GEORGE HALL MPR AND SUPPORT ROOMS PROJECT #19-143

ADDENDUM NO. 2

Date: November 19, 2021

Project: #19-143 George Hall MPR and Support Rooms Project
DSA #: 01-119574 41-26

SHEET NAME:
MECHANICAL FLOOR PLAN

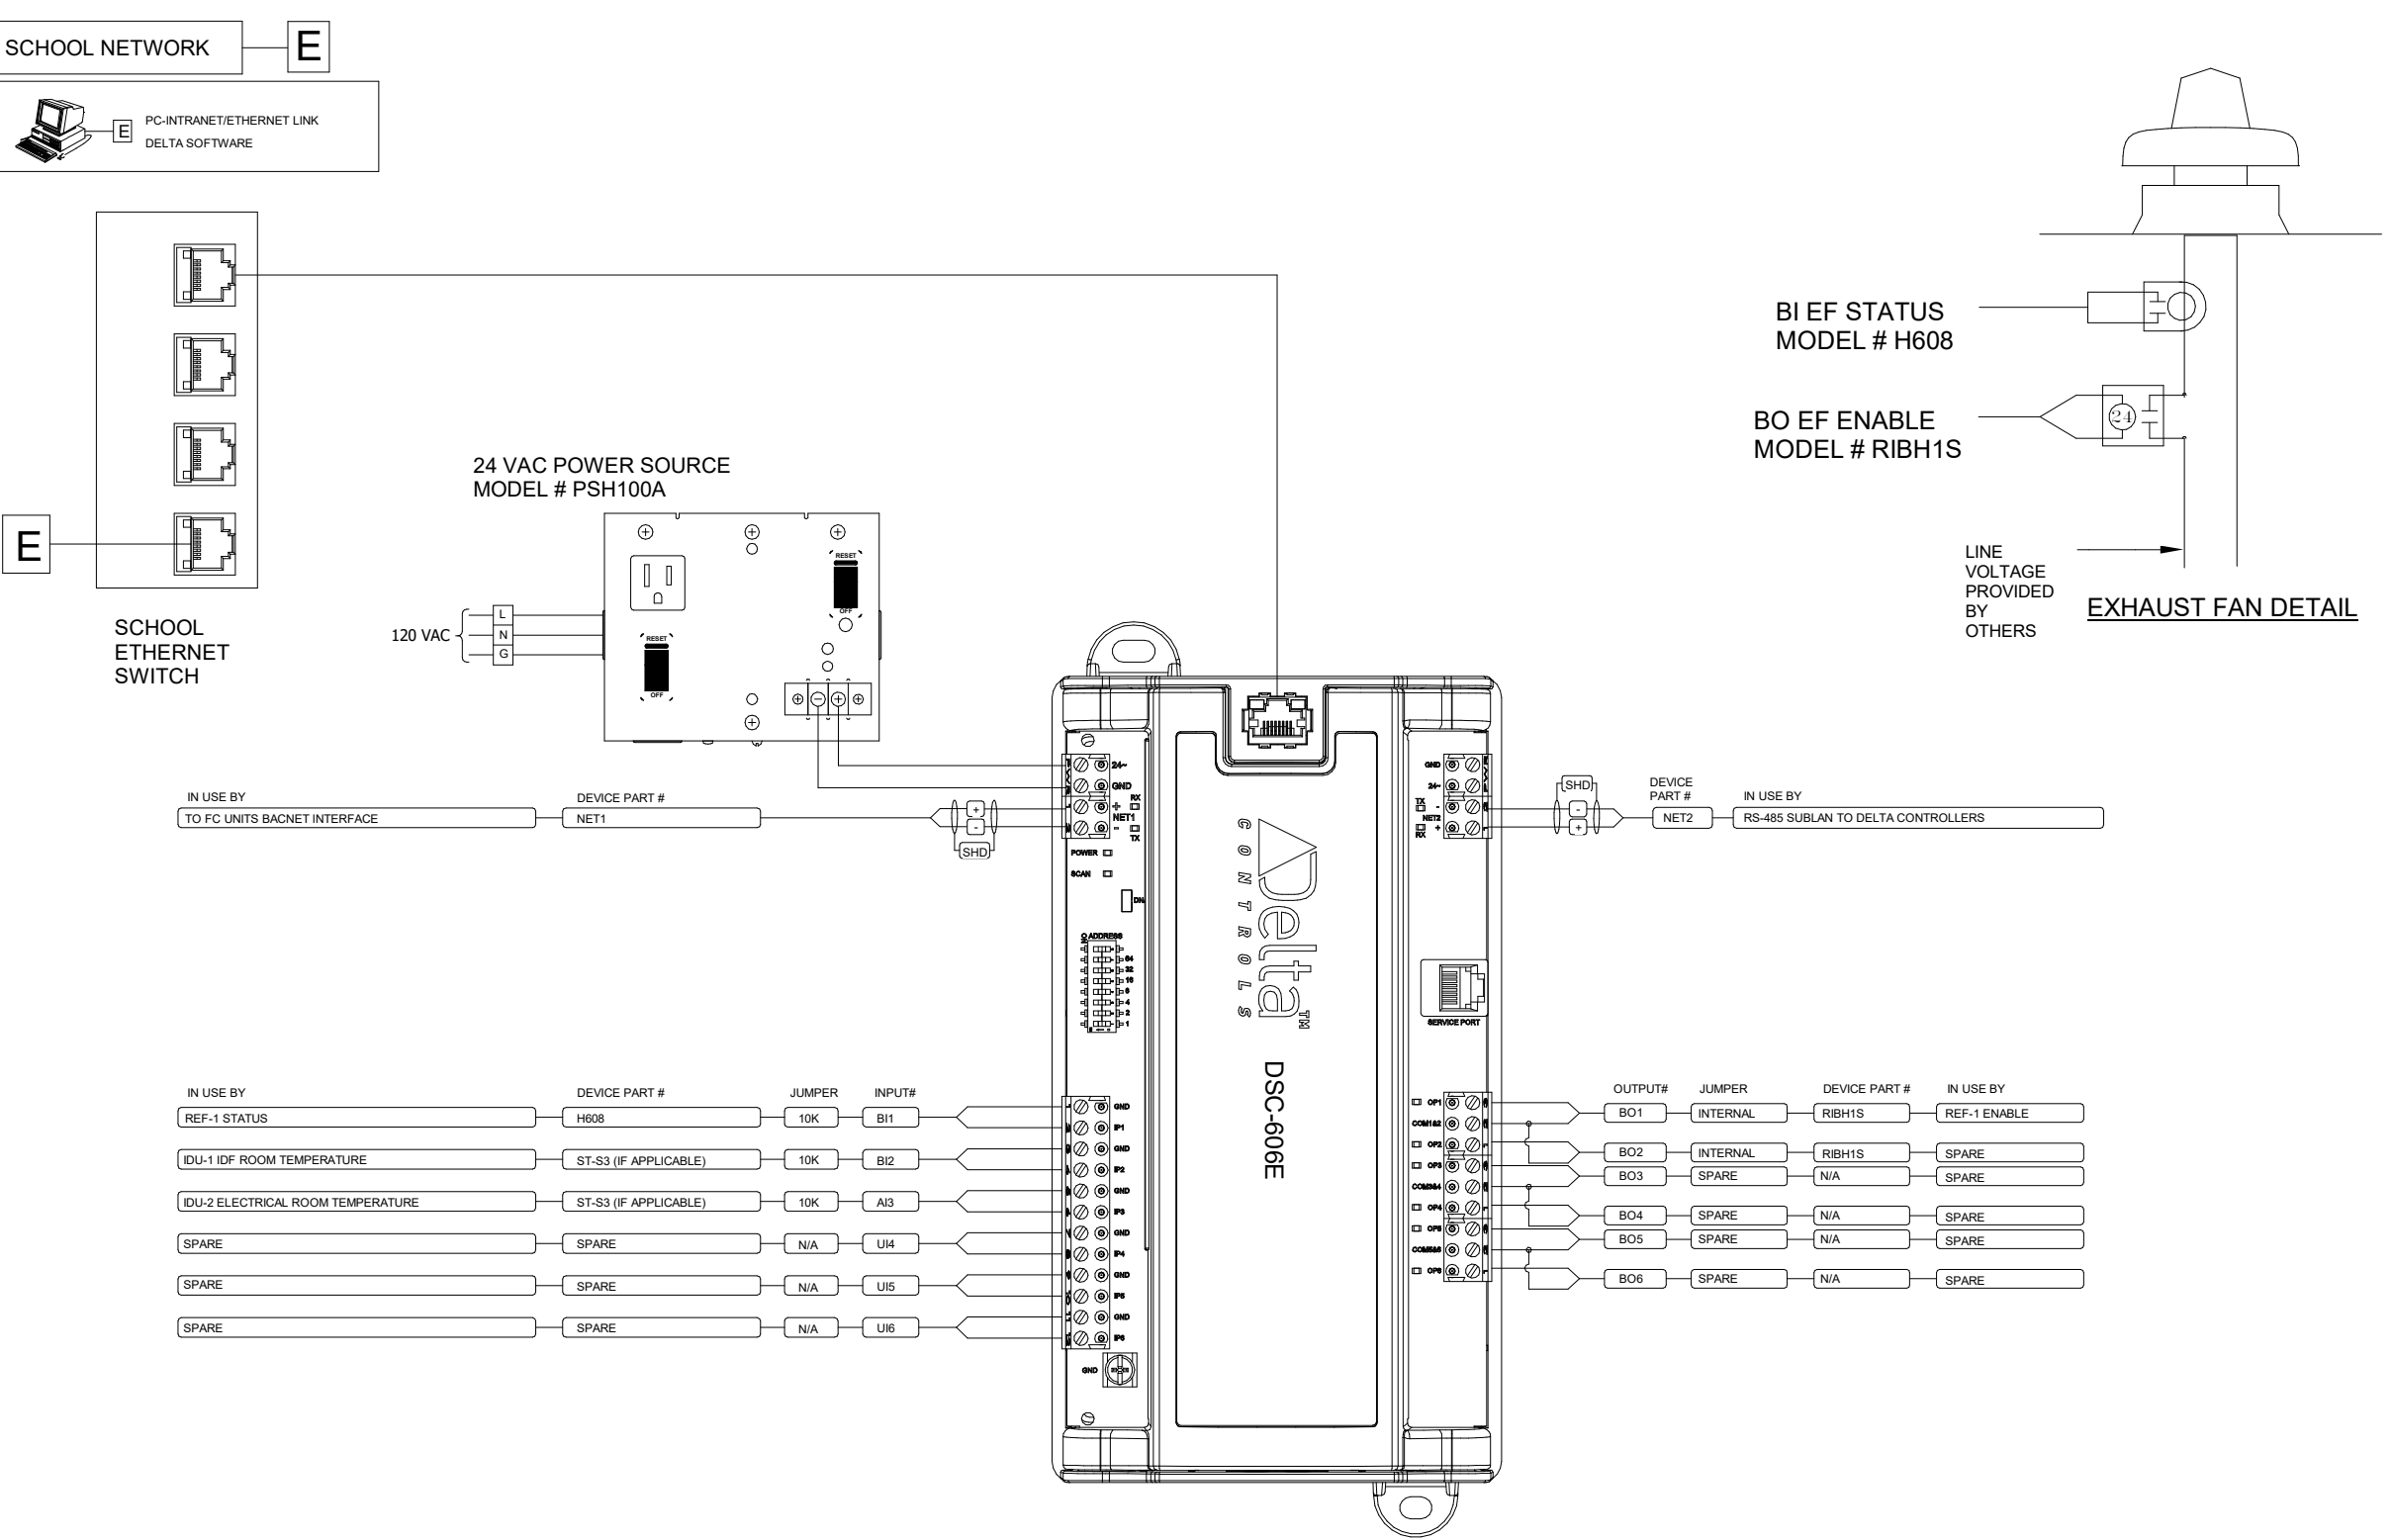
- A. Added detail callouts to Plan.

MECHANICAL CONTROLS

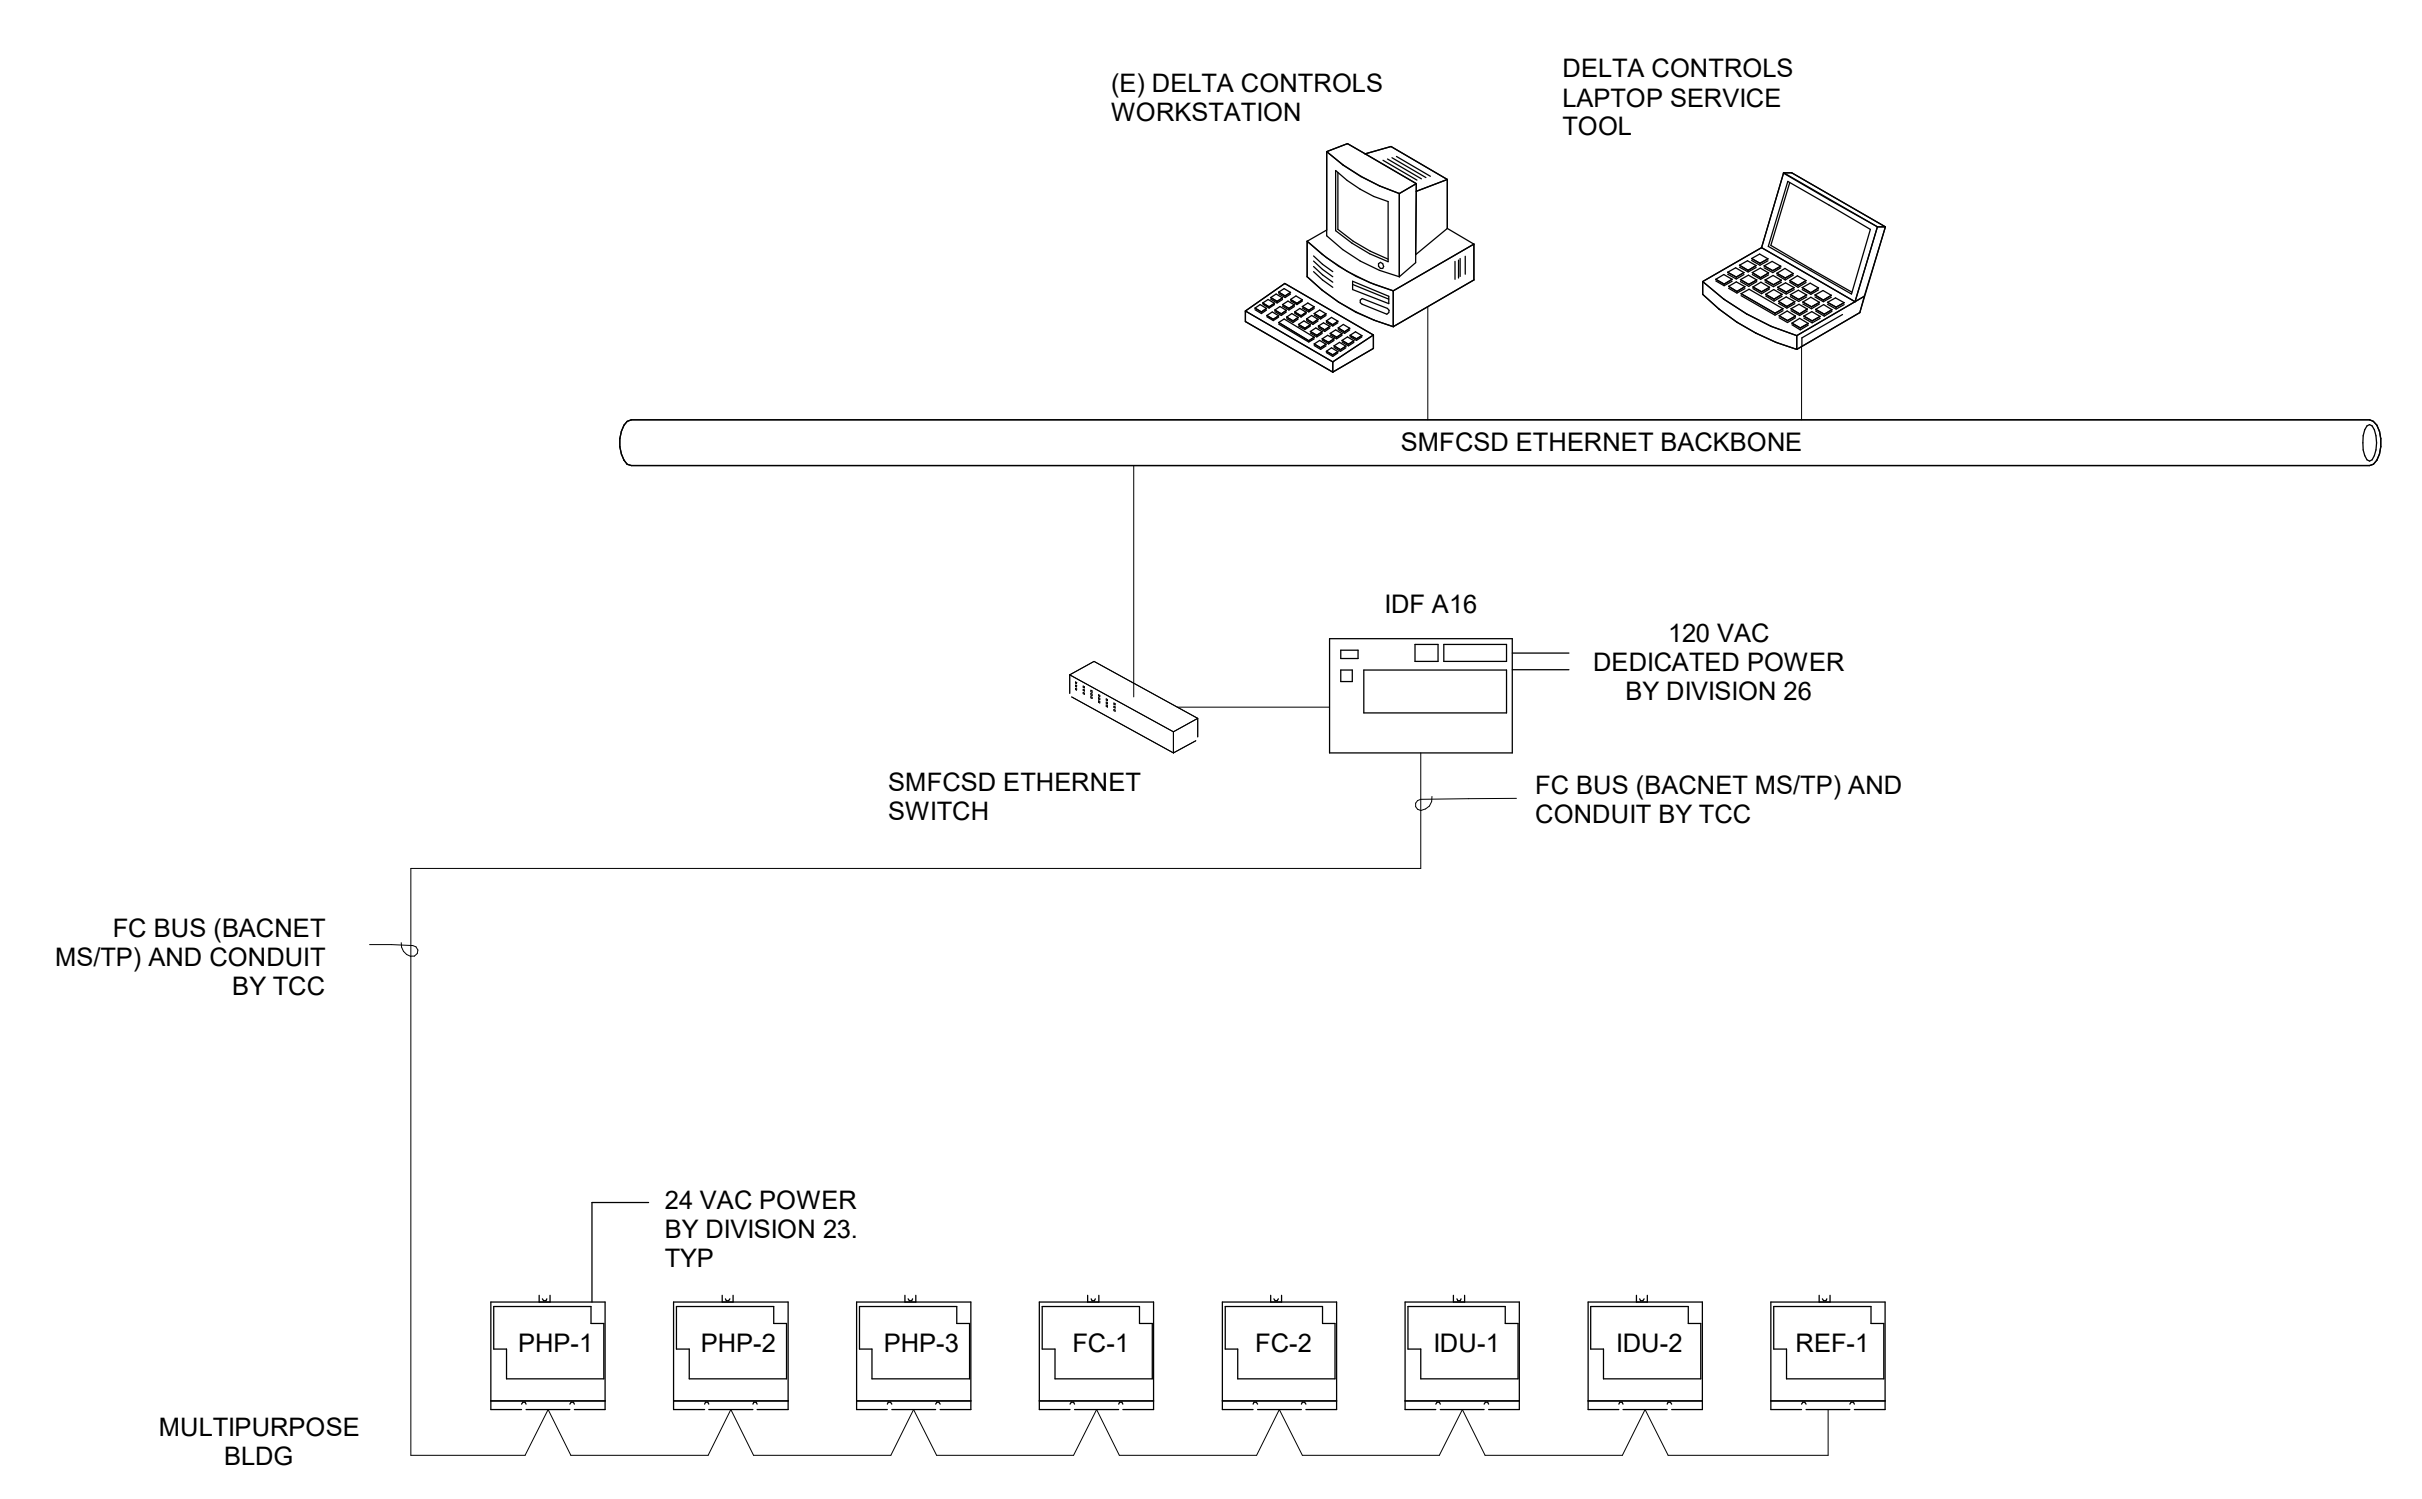
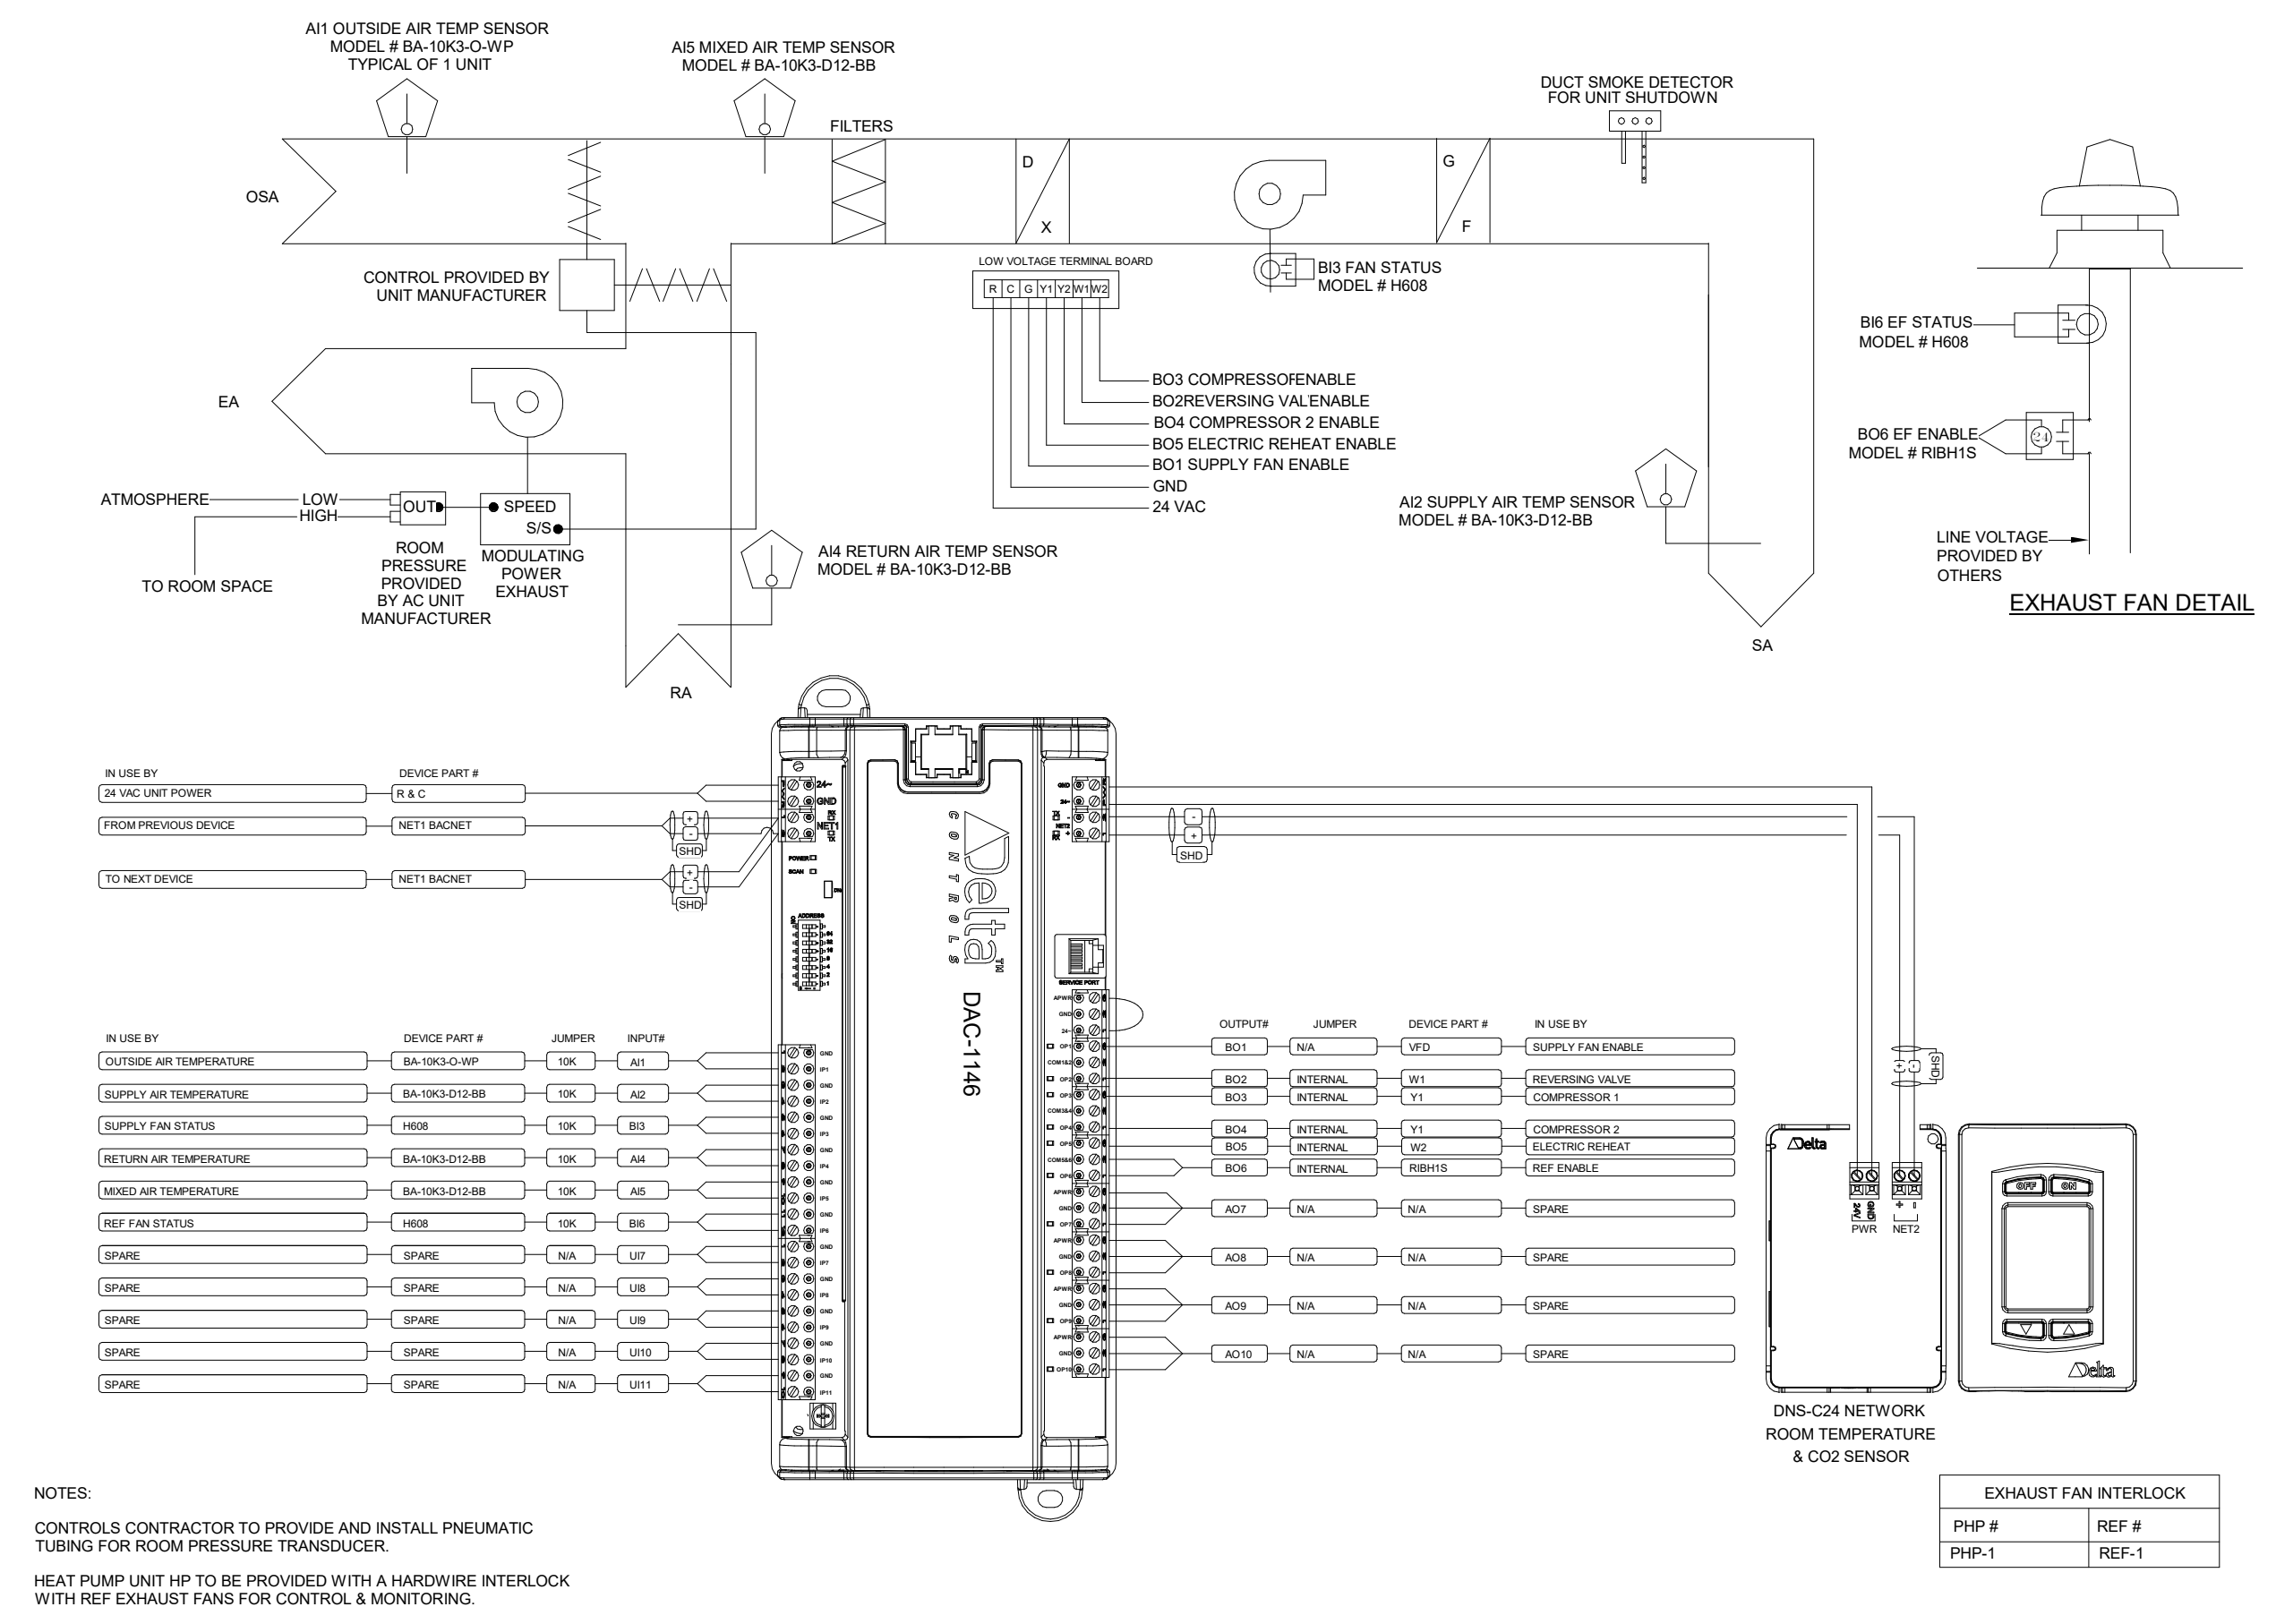
- A. Revised Mechanical Controls.
